Office Action Summary

10/648,937

DETAILED ACTION

This office action is in response to the amendment and remarks filed 6/10/05. Since the examiner has applied new grounds of rejection, this office action is being made non-final to afford the applicant the opportunity to respond to the new grounds of rejection.

Figures 4 and 5 of Liebe

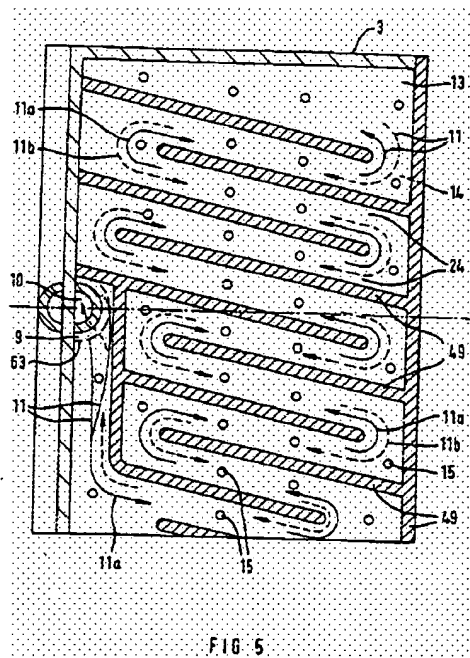
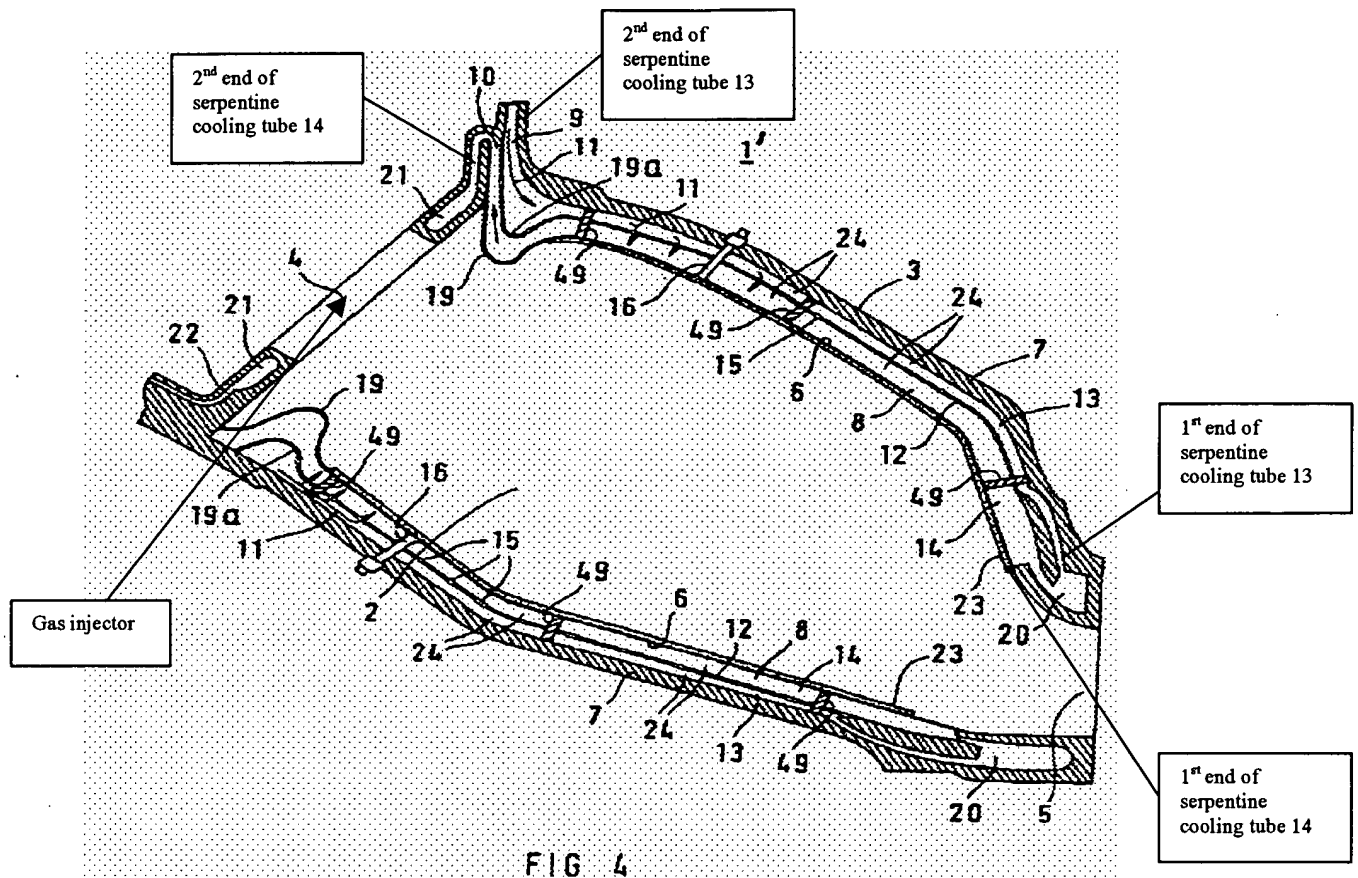
With respect to claims 8, 9 and 11, **Liebe** teaches a cooling tube assembly for cooling a liner (3, 6) of a combustor chamber of a gas turbine engine, the assembly comprising: a plurality of serpentine cooling tubes (13, 14), each serpentine tube conforming to a contour of the liner, each serpentine tube including: a first end in fluid communication with a plenum supplying a fluid to cool the combustor chamber, and a second end in fluid communication with an area in proximity with a gas injector of the gas turbine engine, and a centerline extending from the first end to the second end, wherein the centerline, the first end, and the second end are non-linear when projected onto a plane, wherein each cooling tube has a serpentine shape (see column 5 lines 53 to column 6 line 6) conforming to a contour of the liner (see particularly **Figures 4, 5** of **Liebe**). **Liebe** does not mention that the cooling fluid supplied to the serpentine cooling tubes (13, 14) is air but steam. However, **Liebe** does not restrict supplying the serpentine cooling tubes with steam only, but he only mentions that steam is preferred (column 6 line 66 of **Liebe**). Nevertheless, **Peterson** teaches an apparatus similar to **Liebe** comprising a cooling tube 37 for cooling a liner 41 of a combustor chamber of a gas turbine engine, comprising: the cooling tube having a first end in fluid communication with a plenum supplying air to the combustor chamber, and a second end in fluid communication with an area in proximity with a gas injector 30 of the gas turbine engine, wherein the cooling tube has a serpentine shape conforming to a contour of the liner and the serpentine shape of the cooling tube allows the cooling tube to expand and contract in response to temperature gradients in the combustor chamber (see particularly **Figures 2-4** of **Peterson**). Therefore, **Peterson** teaches that it was well known to a combustor designer (one of ordinary skill in the art) at the time the invention was made to have used air as a cooling fluid for a combustor being cooled by serpentine cooling tubes. Thus, as taught by **Peterson** and

With respect to claim 10, **Liebe** teaches that the cooling tube 14 is positioned outside the combustor chamber liner 3. See particularly **Figure 4** of Liebe.

With respect to claim 12, **Liebe** teaches the cooling tube assembly is in contact with the liner (3, 6). See particularly **Figure 4** of Liebe.

With respect to claim 13, **Liebe** teaches that the cooling tube is maintained a spaced distance from the liner. See particularly **Figure 4** of Liebe.

and each pin 16 having a proximal end attached to the cooling tube and a distal end inserted through the liner (see particularly **Figures 4, 5** of Liebe). **Liebe** does not mention that the cooling fluid supplied to the serpentine cooling tubes (13, 14) is air but steam. However, **Liebe** does not restrict supplying the serpentine cooling tubes with steam only, but he only mentions that steam is preferred (column 6 line 66 of Liebe). Nevertheless, **Peterson** teaches an apparatus similar to **Liebe** comprising a cooling tube 37 for cooling a liner 41 of a combustor chamber of a gas turbine engine, comprising: the cooling tube having a first end in fluid communication with a plenum supplying air to the combustor chamber, and a second end in fluid communication with an area in proximity with a gas injector 30 of the gas turbine engine, wherein the cooling tube has a serpentine shape conforming to a contour of the liner and the serpentine shape of the cooling tube allows the cooling tube to expand and contract in response to temperature gradients in the combustor chamber (see particularly **Figures 2-4** of Peterson). Therefore, **Peterson** teaches that it was well known to a combustor designer (one of ordinary skill in the art) at the time the invention was made to have used air as a cooling fluid for a combustor being cooled by serpentine cooling tubes. Thus, as taught by **Peterson** and since Liebe does not restrict his invention to steam, it would have been obvious to a combustor designer (one of ordinary skill in the art) at the time the invention was made to have used the teachings of Peterson and have supplied Liebes' serpentine cooling tubes 13, 14 with air because air was a well known and commonly used cooling fluid for cooling combustor liners.

With respect to claim 16, **Liebe** teaches that the cooling tube 14 is positioned on an exterior side of the liner 6. See particularly **Figure 4** of **Liebe**.

With respect to claim 17, **Liebe** teaches that the cooling tube 13 is positioned on an interior side of the liner 3. See particularly **Figure 4** of **Liebe**.

With respect to claim 18, **Liebe** teaches that the serpentine shape of each tube is formed as a plurality of alternating bends along a length of each tube. See particularly **Figure 4** of **Liebe**.

wherein the centerline, the first end, and the second end are non-linear when projected onto a plane, (see particularly **Figures 4, 5** of Liebe). **Liebe** does not mention that the cooling fluid supplied to the serpentine cooling tubes (13, 14) is air but steam. However, **Liebe** does not restrict supplying the serpentine cooling tubes with steam only, but he only mentions that steam is preferred (column 6 line 66 of Liebe). Nevertheless, **Peterson** teaches an apparatus similar to **Liebe** comprising a cooling tube 37 for cooling a liner 41 of a combustor chamber of a gas turbine engine, comprising: the cooling tube having a first end in fluid communication with a plenum supplying air to the combustor chamber, and a second end in fluid communication with an area in proximity with a gas injector 30 of the gas turbine engine, wherein the cooling tube has a serpentine shape conforming to a contour of the liner and the serpentine shape of the cooling tube allows the cooling tube to expand and contract in response to temperature gradients in the combustor chamber (see particularly **Figures 2-4** of Peterson). Therefore, **Peterson** teaches that it was well known to a combustor designer (one of ordinary skill in the art) at the time the invention was made to have used air as a cooling fluid for a combustor being cooled by serpentine cooling tubes. Thus, as taught by **Peterson** and since Liebe does not restrict his invention to steam, it would have been obvious to a combustor designer (one of ordinary skill in the art) at the time the invention was made to have used the teachings of Peterson and have supplied Liebes' serpentine cooling tubes 13, 14 with air because air was a well known and commonly used cooling fluid for cooling combustor liners. Since Liebe in view of Peterson has the same structure as claimed, it is inherent that Liebe in view of Peterson device would be able to perform the recited method steps.
